MATANUSKA-SUSITNA BOROUGH

ABBREVIATED PLAT AGENDA ASSEMBLY CHAMBERS 350 EAST DAHLIA AVENUE, PALMER

REGULAR MEETING8:30 A.M.February 21, 2024

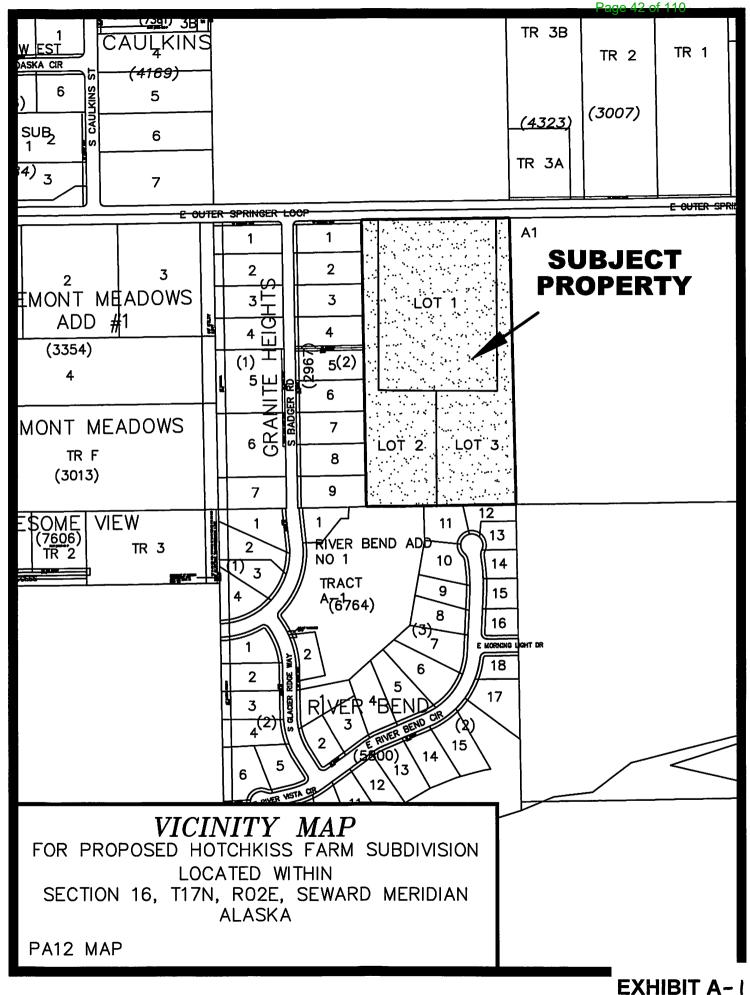
ADOT&PF (Exhibit C) Lots 1, 2 and 3 required to share access. Dedicate common access easement and show this on plat to formalize shared access.

Please remove "unless authorized by the permitting authority" from plat note 6 and change plat note 6 to: "Lots 1-3 shall share a single common access to E. Outer Springer Loop as shown. Subsequent development of Lots 1-3 requires continued use of shared common access easement for motorized use and utility development. No direct motorized access for Lot 2 or Lot 3 to Outer Springer Loop will be permitted. No additional direct motorized access to Outer Springer Loop will be permitted."

EXHIBIT B-4

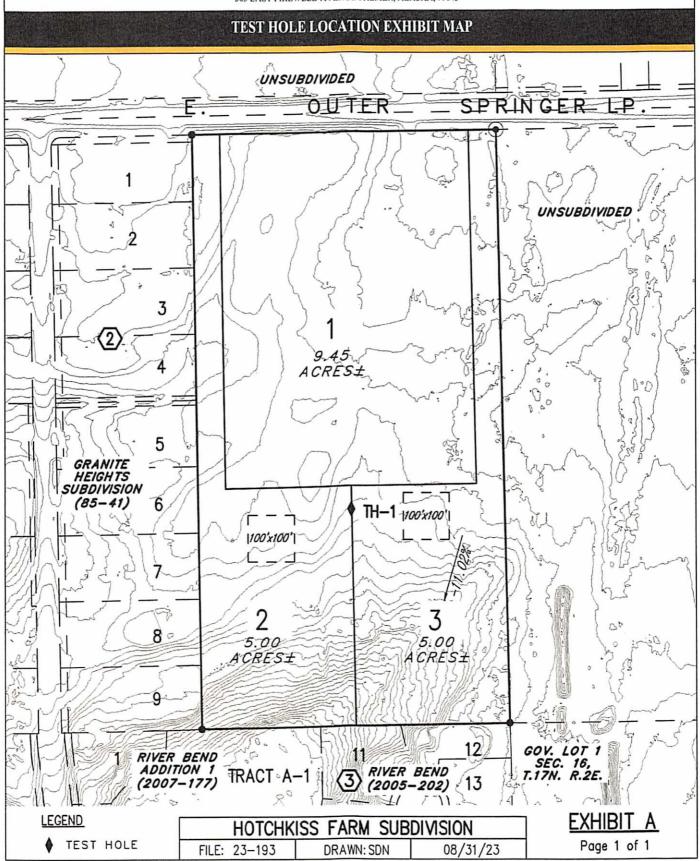
- Lots 1, 2 and 3 required to share access. Dedicate common access easement and show this on plat to formalize shared access.
- No driveways through flag portions of Lots 2 and 3 will be permitted to access Outer Springer Loop Road.

- o Subsequent utility development required through common access easement.
- Please remove "unless authorized by the permitting authority" from plat note 6 and change plat note 6 to: "Lots 1-3 shall share a single common access to E. Outer Springer Loop as shown. Subsequent development of Lots 1-3 requires continued use of shared common access easement for motorized use and utility development. No direct motorized access for Lot 2 or Lot 3 to Outer Springer Loop will be permitted. No additional direct motorized access to Outer Springer Loop will be permitted."

- o DOT&PF will allow existing Pittman Road access to remain for northern lot.
 - Platting actions invalidate existing driveway permits, therefore DOT&PF requires that applicant re-apply for driveway permit for existing Pittman Road access on northern lot. Driveway permits can be applied for at DOT&PF's online ePermits website: https://dot.alaska.gov/row/Login.po. Please contact DOT&PF's ROW division at 1-800-770-5263 to speak with a regional permit officer if you have any questions.

- Please add as plat note: "Subsequent development and subdivision of northern lot may require access to change from Pittman Road to N Treasure St."
 - o DOT&PF requests applicant dedicate right of way along Pittman Road.
